ENGINE - ADDITION OF WASHERS FOR CONNECTION OF THE NF TERMINAL BLOCK AND THE EEC  
HARNESS-CORE - CATEGORY CODE 3 - MOD.ENG-72-0023

V2500-ENG-72-0023

Addition of the washers  
Fig.1

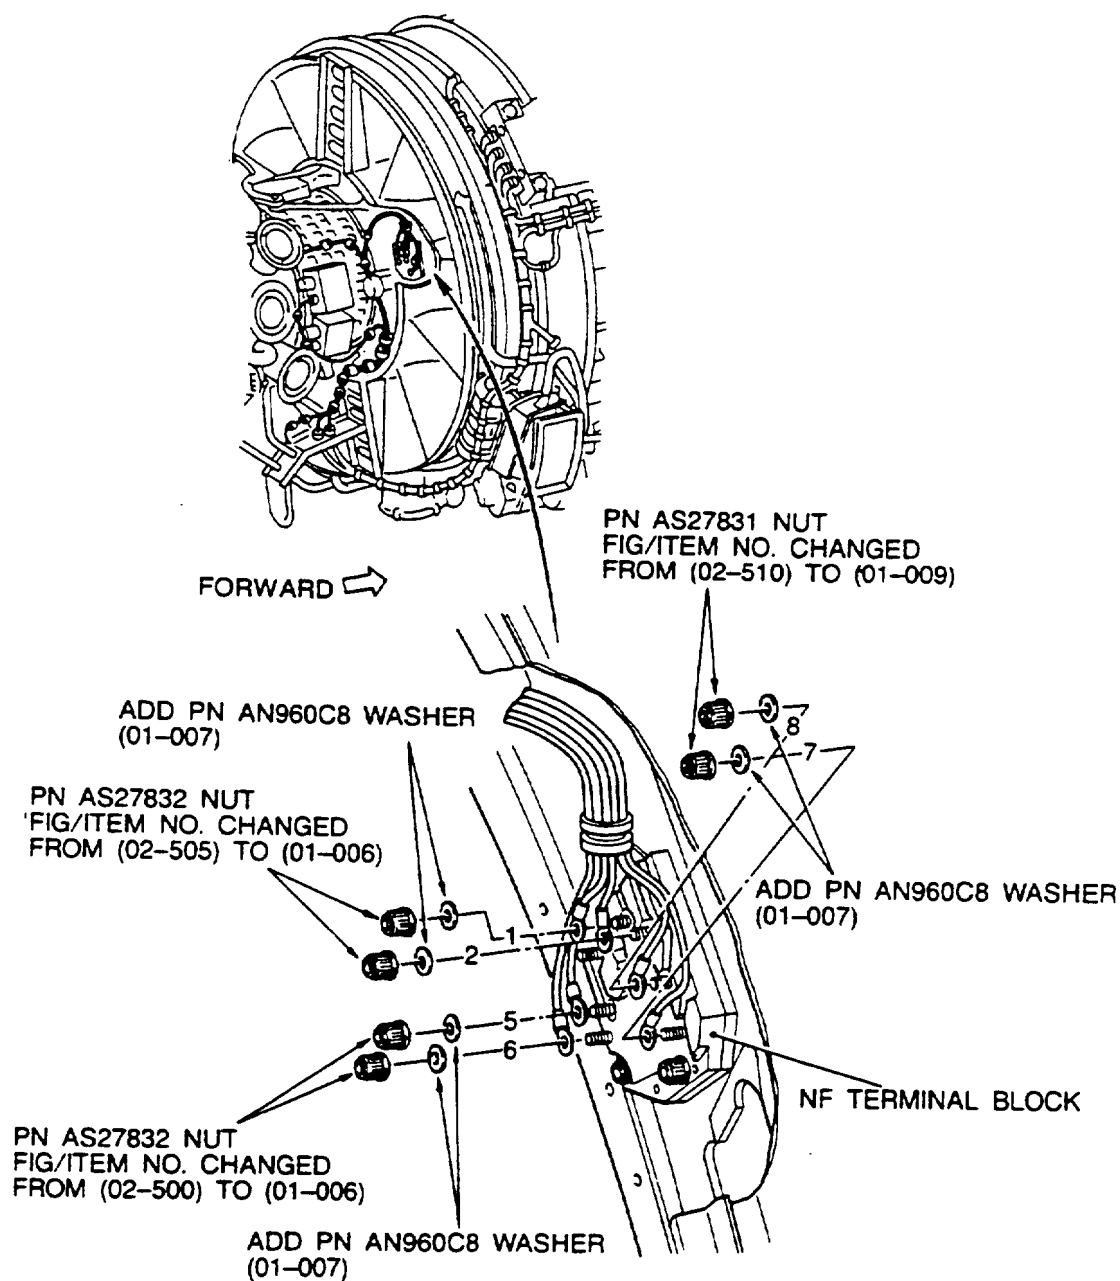
Existing terminal studs on the NF terminal block have excessive shank length. Therefore the terminal of the EEC harness-core has play on the stud, even after the nut is fully screwed. Additional washer was introduced in order to fill the clearance between the nut and the terminal.

Add a washer to each of six terminal studs to get a faultless contact.

- (a) A washer, PN AN960C8 is added to each stud of the six studs on the NF terminal block. The washer places between the terminal of the EEC harness-core and the nut.
- (b) Fig/item numbers of the nuts to retain the terminals are also revised to be consistent with the call outs specified in the Engine Illustrated Parts Catalog.

- (1) Remove two AS27831 Nuts from studs, position seven and eight.
- (2) Install an AN960C8 Washer to each of two studs nut removed.
- (3) Install an AS27831 Nut to each stud.
- (4) Torque the nuts to 10 to 11.5 lbfin (1,13 to 1,30 Nm).
- (5) Remove four AS27382 Nuts from studs, position one, two, five and six.
- (6) Install an AN960C8 Washer to each of four studs nut removed.
- (7) Install an AS27832 Nut to each stud.
- (8) Torque the nuts to 20 to 22 lbfin (2,26 to 2,48 Nm).

Refer to Figure 1.
